SAVE THE SCENIC SANTA RITAS ASSOCIATION

RE: CLEAN WATER ACT 404 PERMIT FOR THE PROPOSED ROSEMONT COPPER MINE

Figure 1. Reproduction from Figure 5 of Eastoe and Gu (2016) showing the contribution of water from Cienega Creek (noted by "C" on the map) to groundwater under Tucson and Vail.

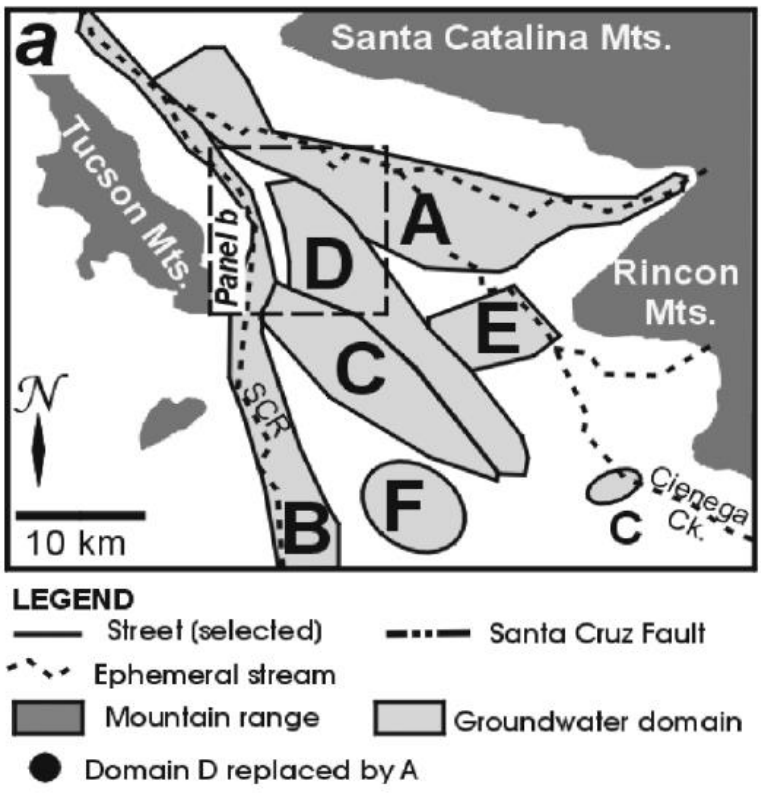
A new publication (Eastoe and Gu 2016; (Attachment 1A) documents that the groundwater under Tucson originated from the Cienega Creek watershed. Water derived from Cienega Creek can be identified in the groundwater by the chemical signature of Permian marine sulfates that are not present in the Tucson Basin. Figure 1 below shows the spatial extent of the aquifer affected by recharge from this watershed. It extends from the Vail area to The University of Arizona campus and further down-gradient into downtown Tucson. Thus, the risks of waterborne pollutants

conveyed from the mine are not solely ecological; pollutants from mine seepage or downstream recharge would flow by gravity toward potable water supplies for Vail and Tucson.

Figure 2. Location of water quality monitoring locations in relation to Outstanding Arizona Waters (Davidson Canyon and Cienega Creek).

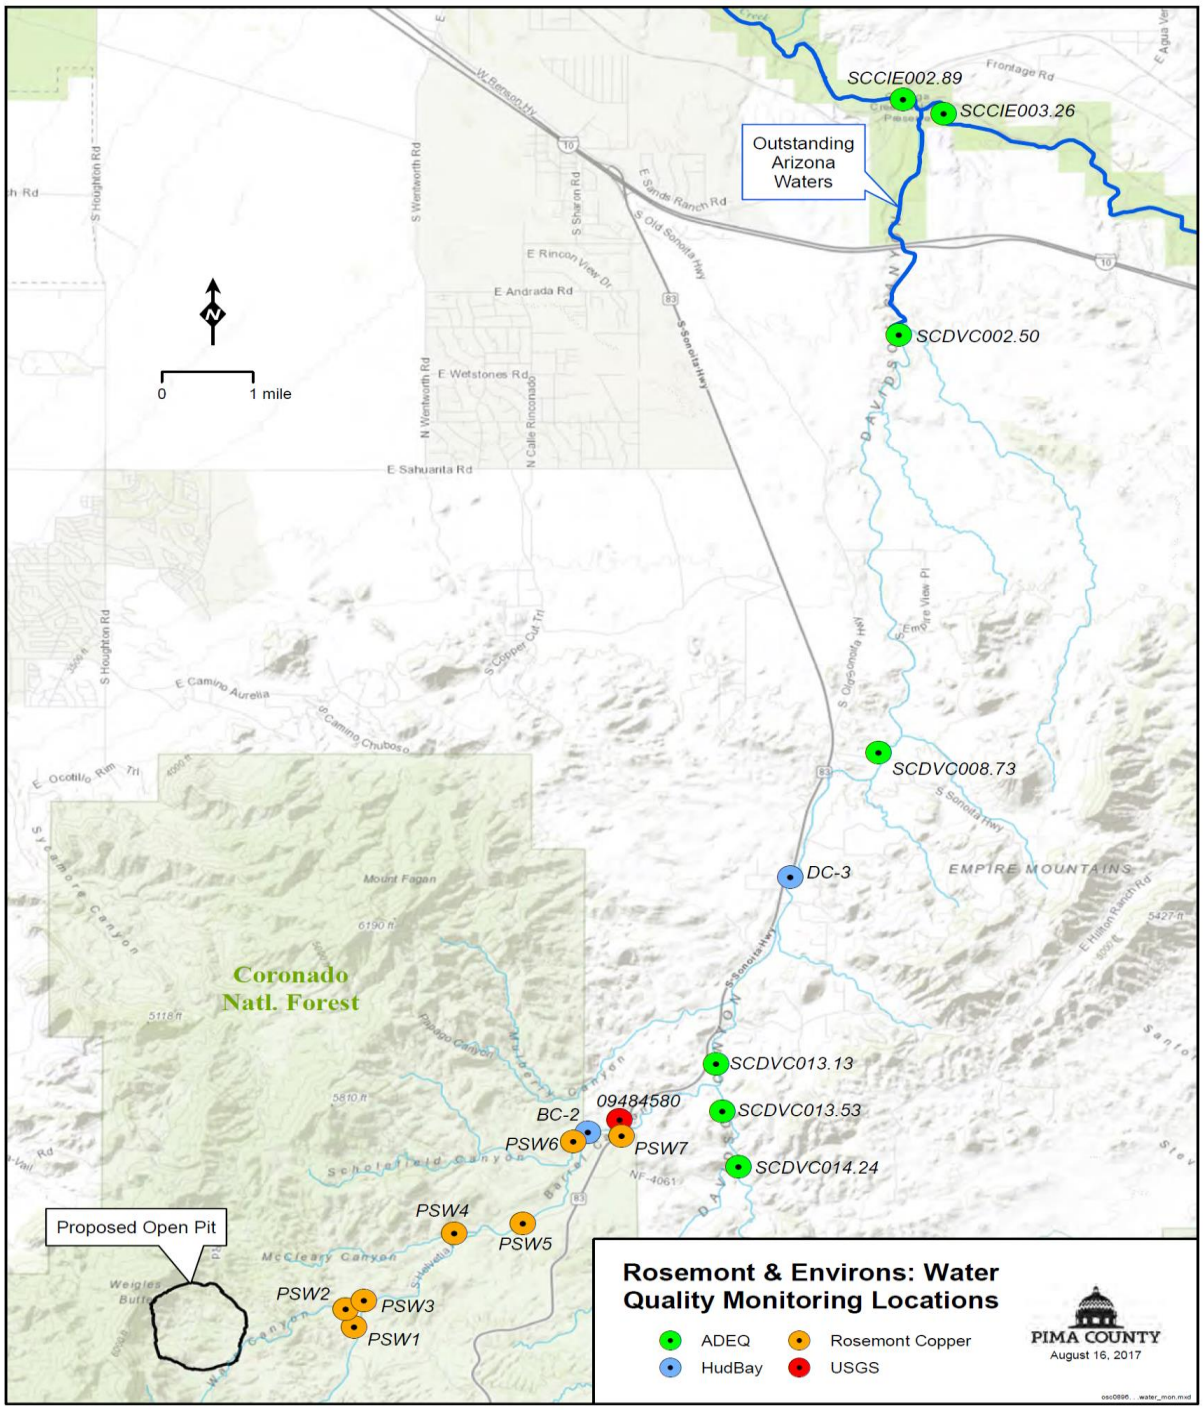
The stormwater quality samples Hudbay referred to at the April 2017 Corps meeting are derived from their DC3 sampling site, which lies over seven channel-miles upstream of the OAW (Figure 2). Pima County has prepared the figure below to show the locations and names given to various water quality monitoring locations by the operators.

DC3, Barrel Canyon and tributaries upstream of the OAW show many repeated sampling events with metal concentrations exceeding state standards, including dissolved copper and total lead in stormwater runoff (Attachment 4, Pages 5 through 14). Copper is of particular concern because this metal constituent is shown to be in solution and therefore more available for biochemical reactions.

Figure 3. Peak and base flows in July and August 2017 at USGS Gage 09484580. Base flows persisted long after the last measured rain at the gage (August 3, August 15).

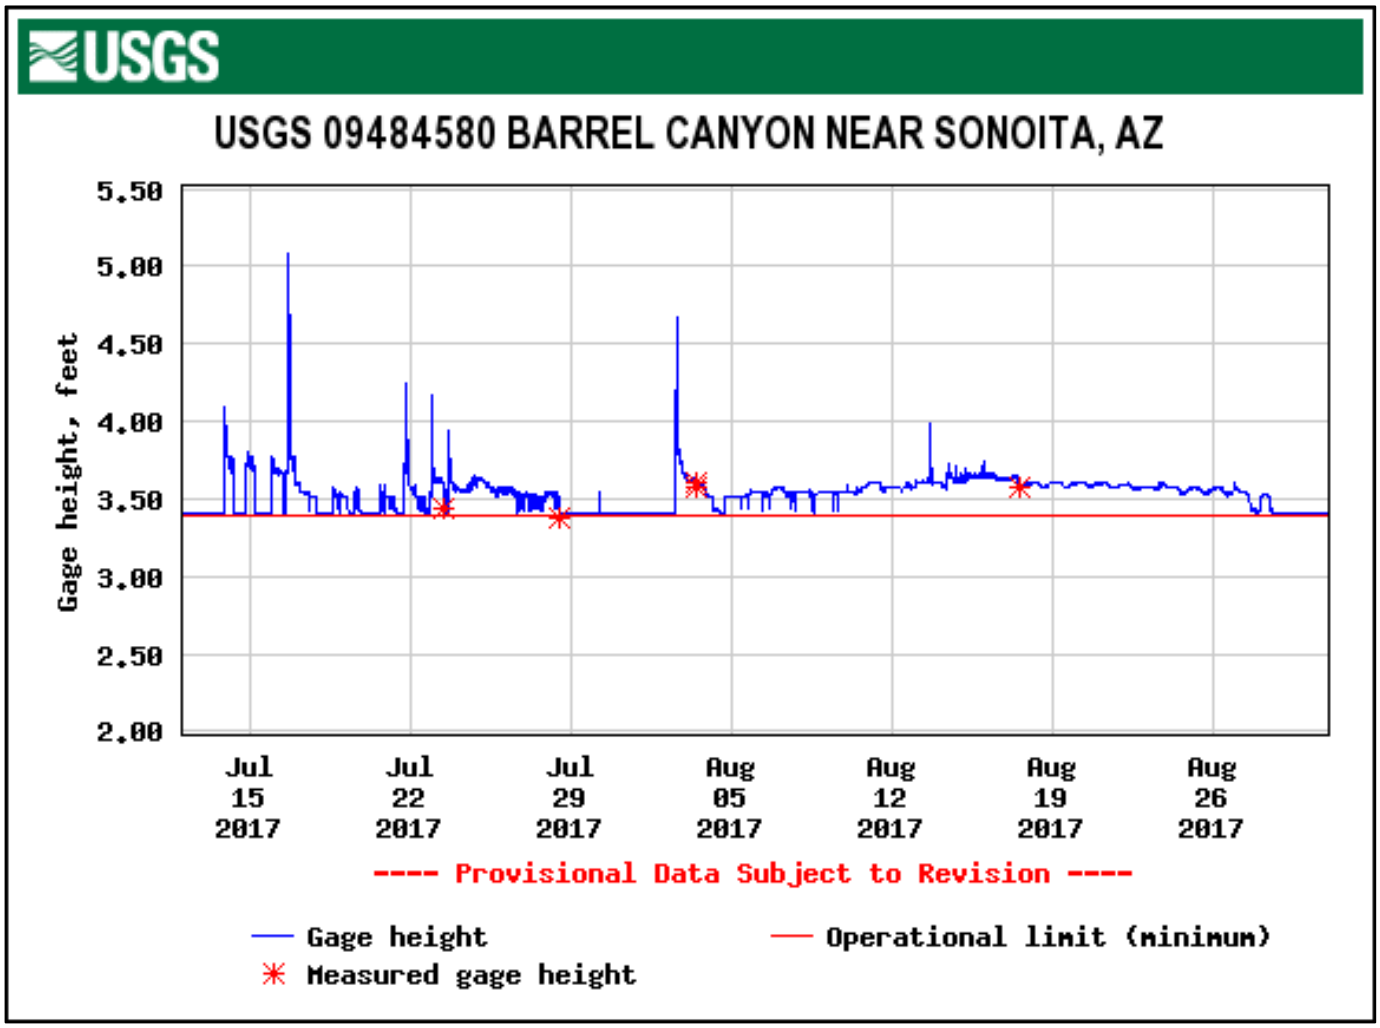
In recent years, the USGS has more thoroughly identified the frequency, magnitude and duration of flows at USGS Gage #09484580, located at a culvert under Highway 83, upstream of "Barrel Spring" (Figure 3). The gage is located at a point within the PAG-mapped intermittent flow reach. USGS staff periodically visit the stream gage to perform maintenance and rate the accuracy of flow measurements. During visits, USGS documents actual stream flow conditions using direct measurement of flow and visual observations.

The table in Attachment 5 shows the days since last rain when USGS documented flows using field observation. The record shows recent events where base flows persisted as long as 14 days after rainfall (January 25, 2016). This monsoon, there were two periods with base flows for a number of consecutive days in July and August, which are shown in the graph below. Red Xs indicate the date of field observations at the gage by USGS personnel. Storm flows are shown by the sharp rises with a "tail," and the base flows by the relatively stable low flows in between the peaks.

Figure 8. Sediment sampling locations in the Davidson watershed, from Hawkes (1976)

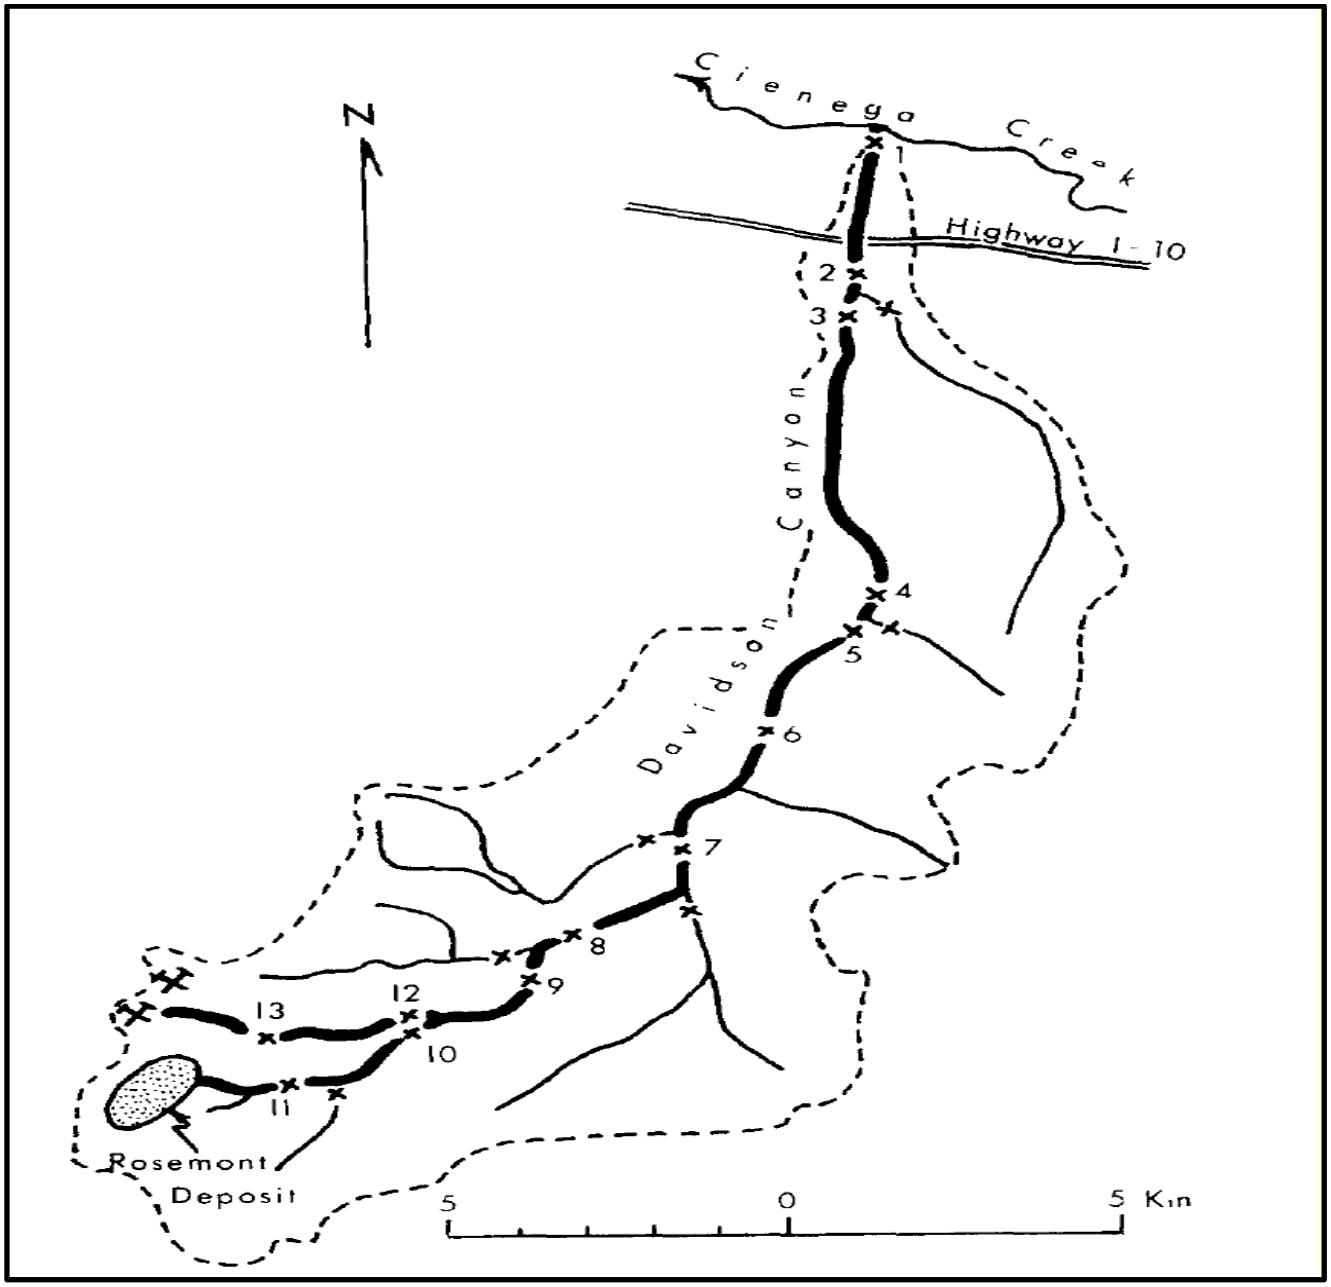
A paper from the Journal of Geochemical Exploration (Hawkes 1976) documents the sources of copper anomalies in sediments tributary to Cienega Creek (Figure 8 below, from Attachment 8). The anomalous values are identified as having sources in Barrel Canyon and "old copper prospects" in McCleary Canyon. These areas have been affected by many previous mine-related activities.

Figure 10. Map of all known drill holes and areas of historic mining activity from recent cultural resource documentation.

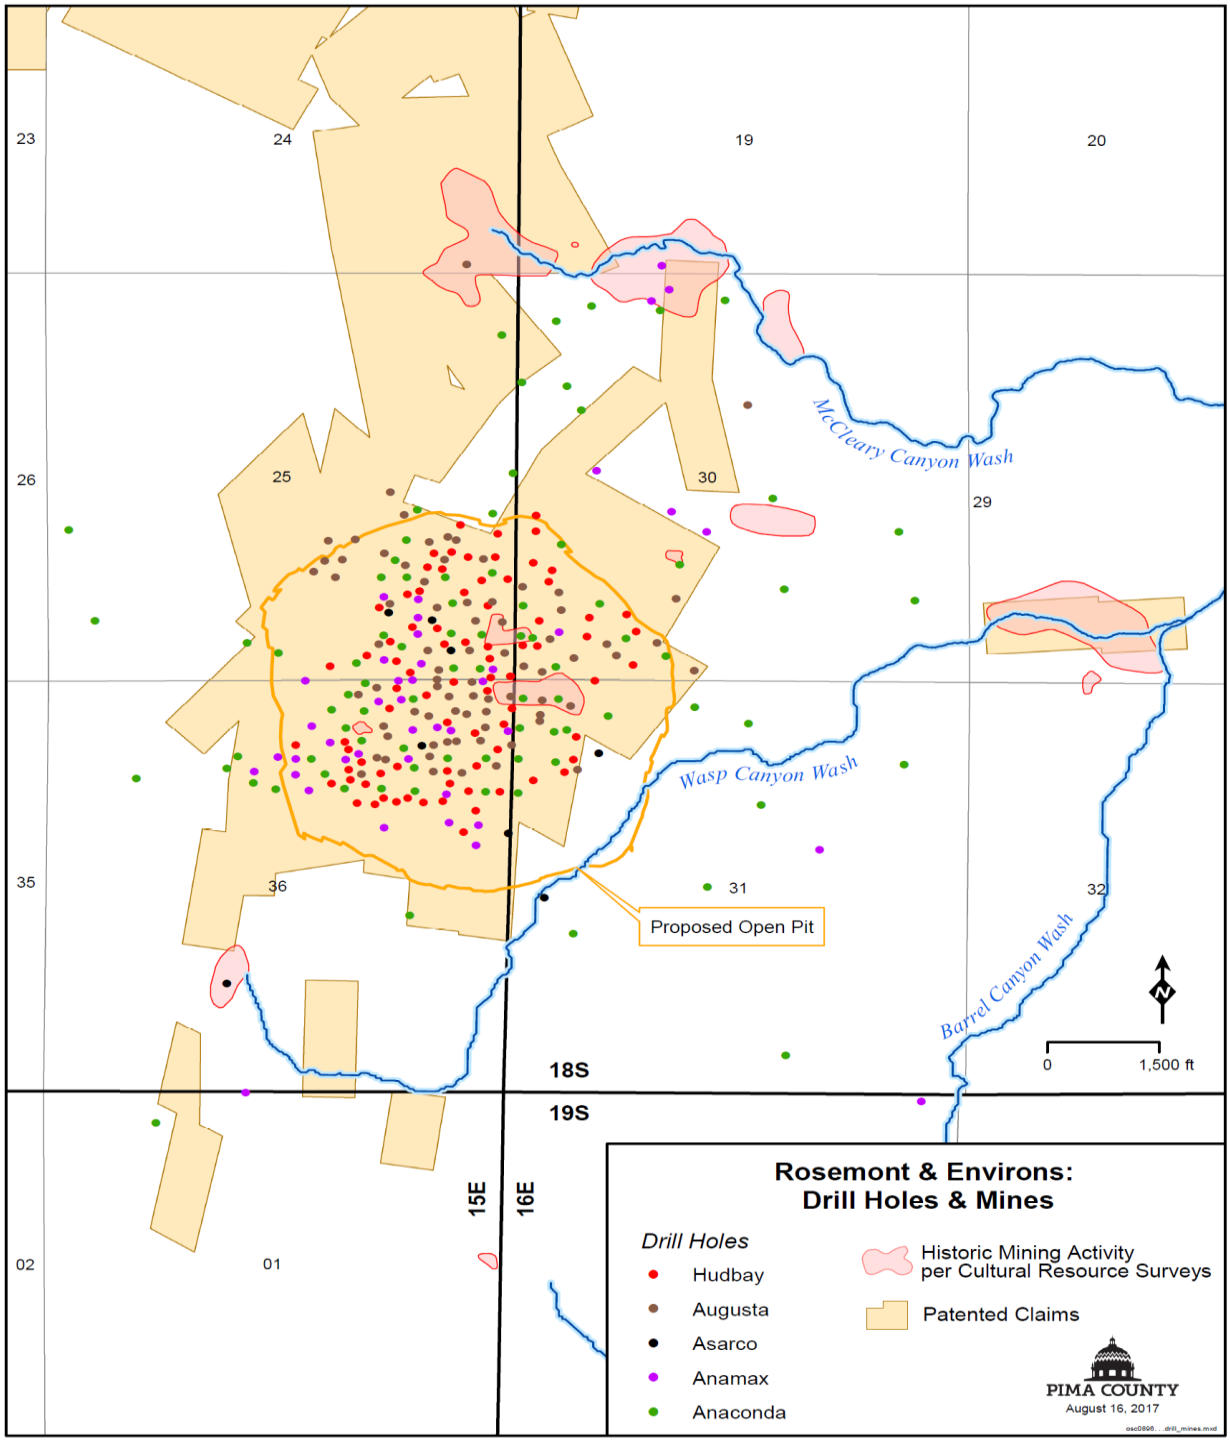
Figure 10 below compiles all of the drill holes and areas of historic mining activity from recent cultural resource documentation for the first time. Drilling of boreholes and road construction to provide access can generate finely comminuted sediments, which may be contributing pollutants to runoff. Historic mining district activities shown along Wasp and McCleary may have included ore processing or assaying activities, as well as blasting or otherwise liberating mineralized bedrock.

Finally, because prior to 1993, many holders of unpatented mineral claims performed a minimum of $100 in assessment work each year in order to justify their claims, we provide in Attachment 9 a map of Rosemont's unpatented claims, which can be seen to cover nearly the entire watershed of Barrel Canyon.

Prior to issuing permits to renew mining, the Corps and USFS should be investigating the possibility that past mine-related activities have contributed to pollution in groundwater or surface water emanating from Barrel Canyon and now detectable in stormwater. You are no doubt aware of the court decisions regarding Comprehensive Environmental Response, Compensation, and Liability Act cleanup costs. It seems prudent to clarify the situation now, rather than after dredge and fill activities begin.

Figure 1. In red, areas of former mine-related activities based on cultural resource surveys. Drill holes in yellow. Location of stock tank removals shown in green and are approximate.

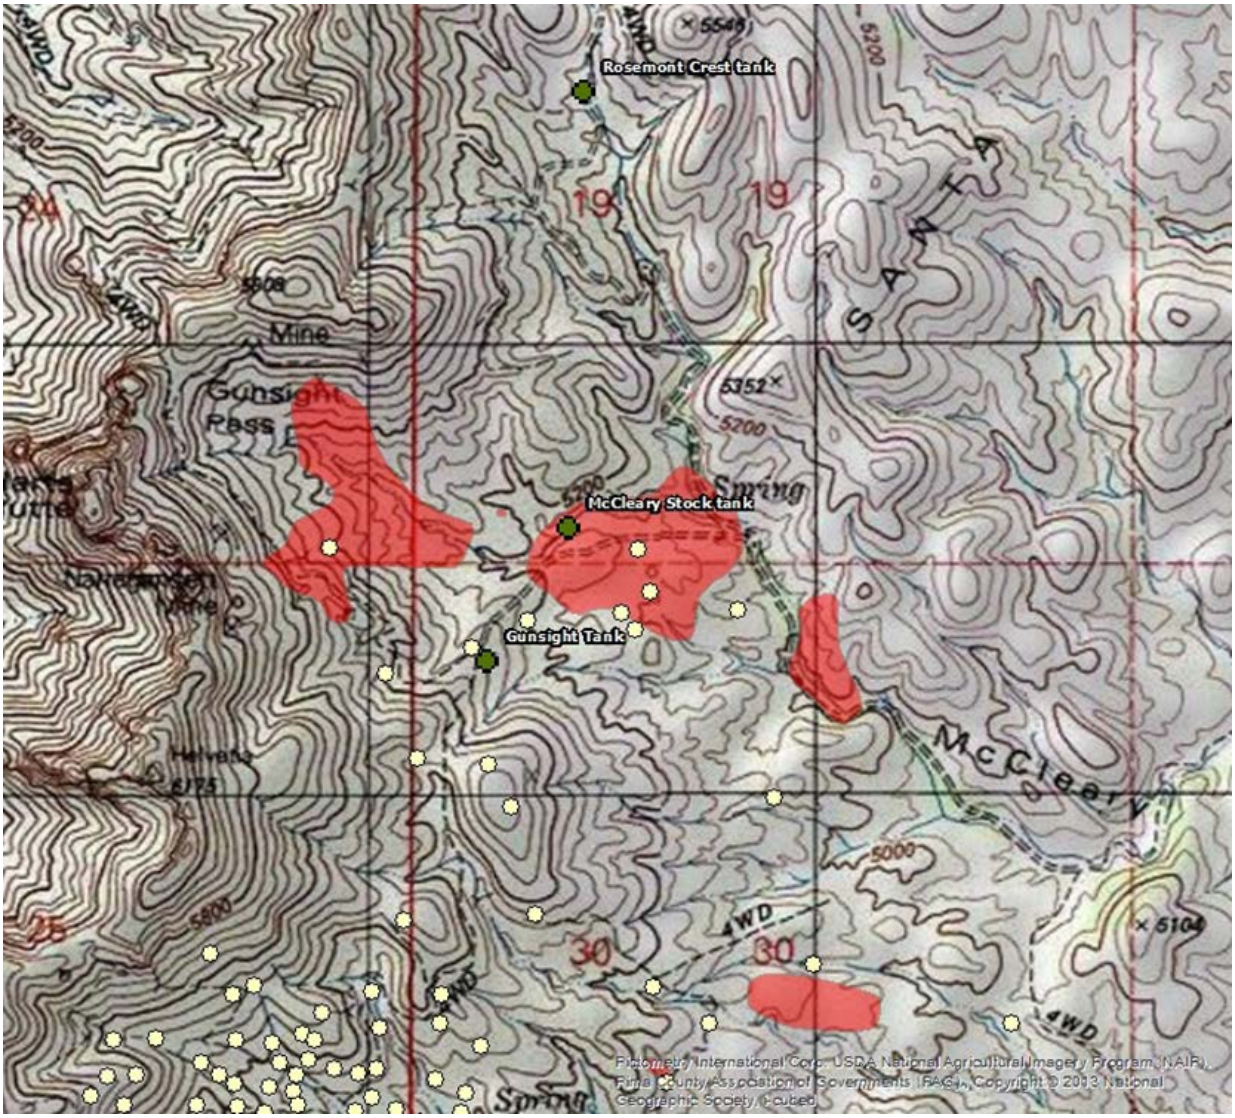
Rosemont is proposing to eliminate four dirt tanks within the project footprint to allow stormflow to be conveyed downstream. In two of the watersheds (McCleary Stock Tank and Gunsight Tank) there has been historical mining activities (see map below; red areas are historic mining sites as determined from cultural resource surveys and yellow dots are historical drill holes). The impact of disturbing soils associated with these features and conveying unknown—and unanalyzed—contaminants downstream has not been analyzed as part of the Biological Opinion or FEIS.

Hudbay (2015) data show that under current conditions, which include numerous mining features and land disturbance upstream, base flows of springs are of good quality. Elevated levels of dissolved copper, and total lead and copper have been consistently observed in stormwater at monitoring site PSW-4. Upstream spring flow met the livestock standards (Tetra Tech memorandum dated May 5, 2009). Would release of stored sediment increase ambient metal concentrations? Further study is warranted before the state can draw a conclusion that existing uses will not be impaired by the dredge-and-fill activities upstream, which include the stock tank removals. The stock tanks in the upper McCleary watershed are located below old mining claims which were historically worked (Figure 1).

Figure 1. In red, areas of former mine-related activities based on cultural resource surveys. Drill holes in yellow. Location of stock tank removals shown in green and are approximate.

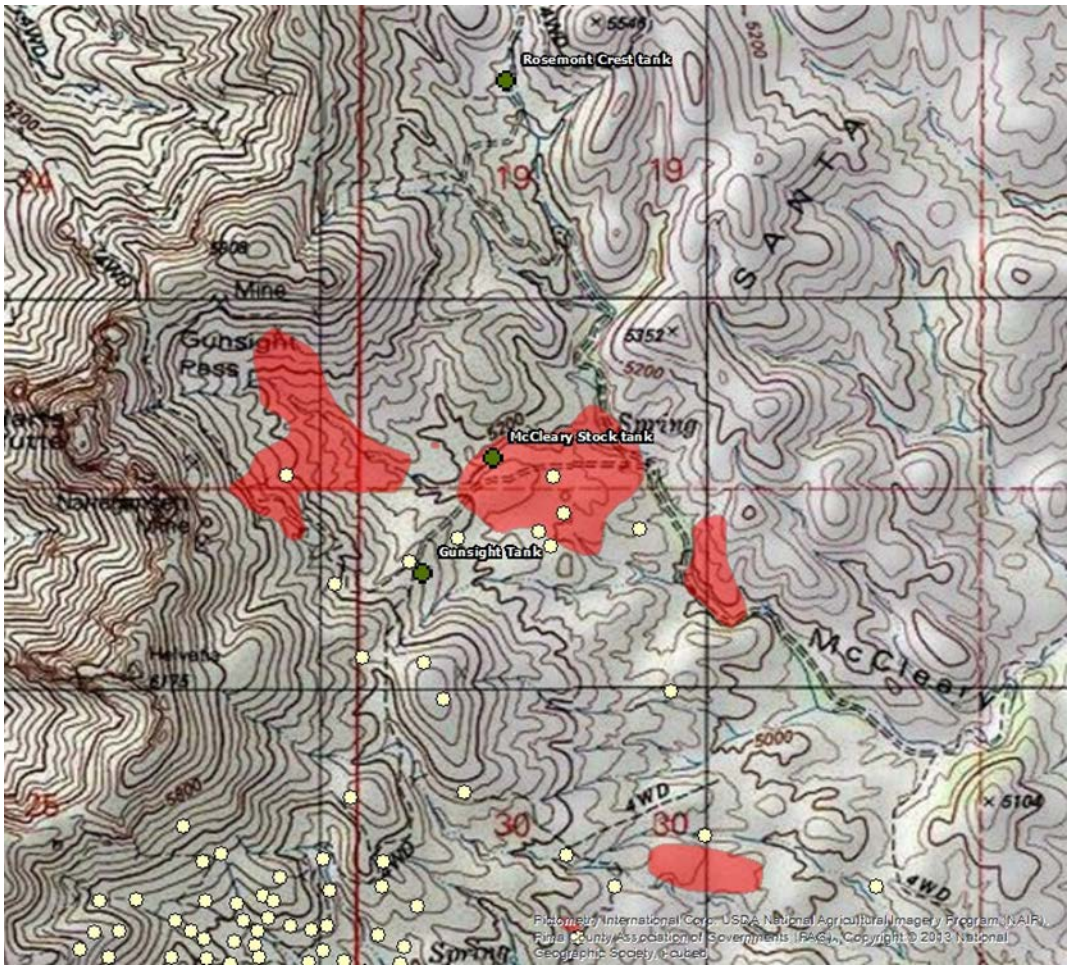
Rosemont is proposing to eliminate four dirt tanks within the project footprint to allow stormflow to be conveyed downstream. In two of the watersheds (McCleary Stock Tank and Gunsight Tank) there has been historical mining activities (see map below; red areas are historic mining sites as determined from cultural resource surveys and yellow dots are historical drill holes). The impact of disturbing soils associated with these features and conveying unknown—and unanalyzed—contaminants downstream has not been analyzed as part of the Biological Opinion or FEIS.
